*Proceedings of the Madras Government, Public Works Department,
14th February 1876.*

No. 224. *Note by the Chief Engineer for Irrigation.*

ORDER THEREON, 14th February 1876, No. 391.

IRRIGATION, No. 24.

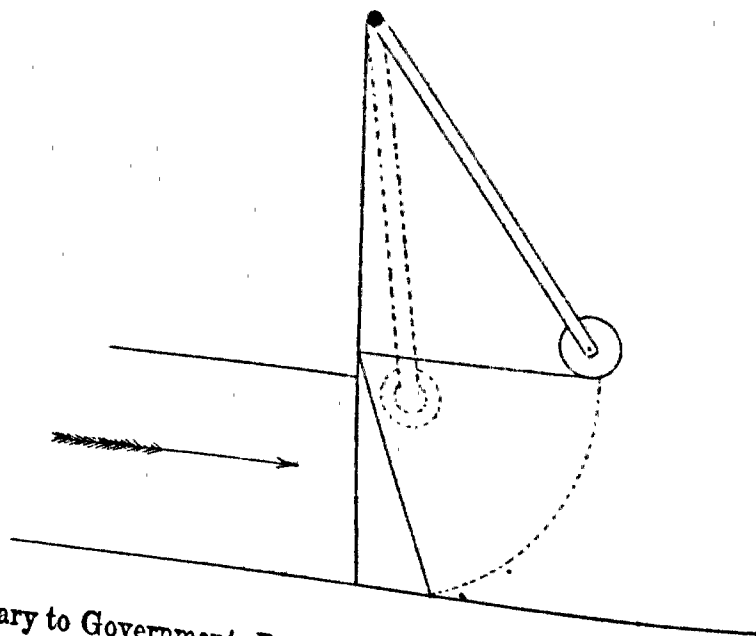
3. Shutters may be prevented by stops from rising higher than the horizontal position, and they will then be less liable to need weighting. Moreover, as extra weight is required rather to commence their depression than to ensure their coming home to their seat after downward movement has been originated, a good form of weighting is one which would be at or near the lower edge of the shutter when

horizontal, and nearer the line of suspension when shut. This arrangement can be effected by applying the weight in the form of a roller with radial arms hinged at a point on the face wall, about $1\frac{1}{2}$ times the length of the shutter above the hinges of the latter, *vide* diagram.

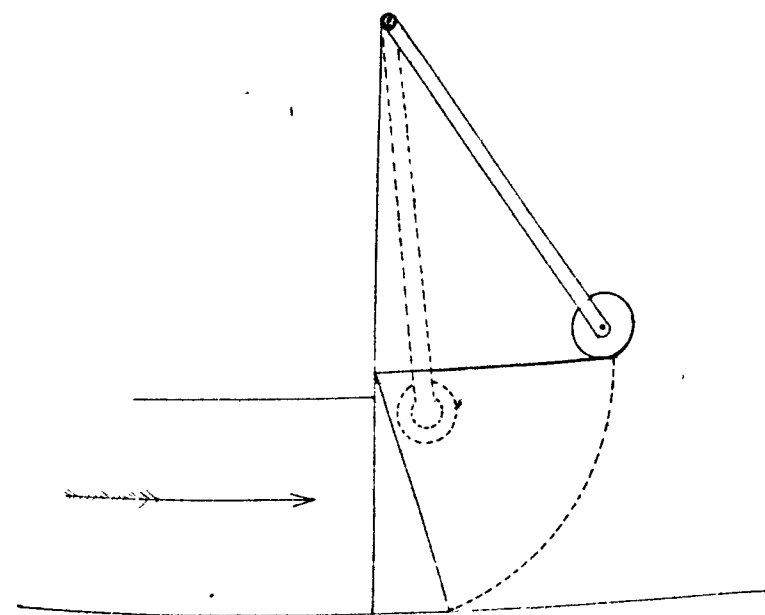
3 Shutters may be prevented by stops from rising higher than the horizontal position, and they will then be less liable to need weighting. Moreover as extra weight is required rather to commence their depression than to ensure their coming home to their seat after downward movement has been originated, a good form of weighting is one which would be at or near the lower edge of the shutter when horizontal, and nearer the line of suspension when shut. This

arrangement can be effected by applying
 the weight in the form of a roller
 with radial arms hinged at a point
 on the face wall about $1\frac{1}{2}$ times the
 length of the shutter above the hinges
 of the latter, vide diagram.
